Comment Letter O21b

**Subject:** Newport Banning Ranch DEIR Comment II  
**Attachments:** NB General Plan Banning Ranch Development Constraints.pdf; NBR DEIR Master Development Plan.pdf; USFWS CAGN Critical Habitat.jpg; USFWS NBR Fairy Shrimp Map.pdf; NBR DEIR Vernal Pool Interpretive Area.pdf; NBR DEIR Comment Letter I 101411.pdf

Re: Newport Banning Ranch DEIR Comment II

Figure 3  
Historic Oilfield Impacts Map

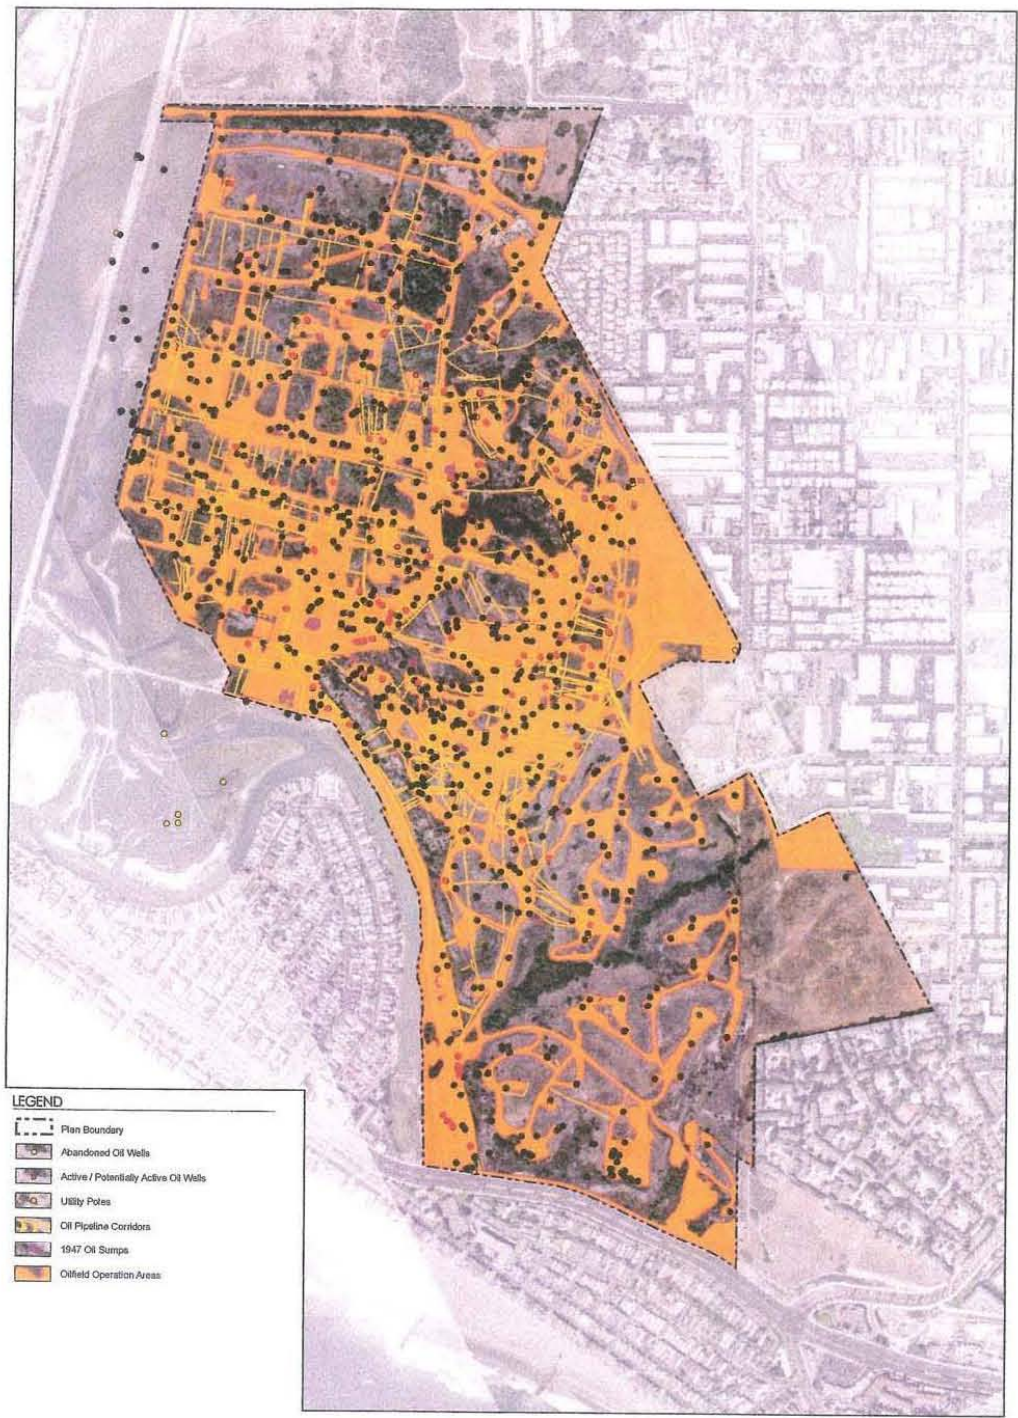
(\*\*) **There currently remains over 40 miles of pipelines throughout the Site for the conveyance of oil, water, and gas produced from the wells to various separation and treatment facilities on the Site.** Figure 3 shows that these operations are spread across both the upland and lowland areas of the Site.

Figure 3 provides a composite picture as to the extent of the Site that has been impacted by both historic and current oil wells, pipelines, utility poles, and related facilities, as well as oilfield operation work areas like graded roads and equipment areas surfaced with gravel, asphalt, **crude oil, or crude oil tank sediments, and historic sumps which held produced oil and fluids within in-ground surface impoundments.** This map was assembled from a variety of in-field evaluations, technical maps, aerial photography, and other sources, **and illustrates that the over 65 years of oil producing operations have resulted in substantial impacts to the Site.**

A copy of Figure 3 is attached. It can also be viewed at the above link, in the "Figures" section of the DRAP.

All of the equipment associated with Figure 3 is subject to corrosion, contamination, leakage, seepage and fugitive emissions, which would be true even if the operation hadn't been situated over the Inglewood-Newport Beach

Figure 3, Historic Oilfield Impacts Map, in the draft Remedial Action Plan distinguishes between active/potentially active oil wells and abandoned oil wells. With the exception of the two oil consolidation sites, all on-site oil wells would be abandoned or re-abandoned to current DOGGR standards. The mineral rights below the Project site are owned by West Newport Oil Company, which is wholly owned by Horizontal Drilling LLC. While the City's oil well surface locations are within the Project site, they produce from locations outside of the Project site by use of directionally drilled wells.
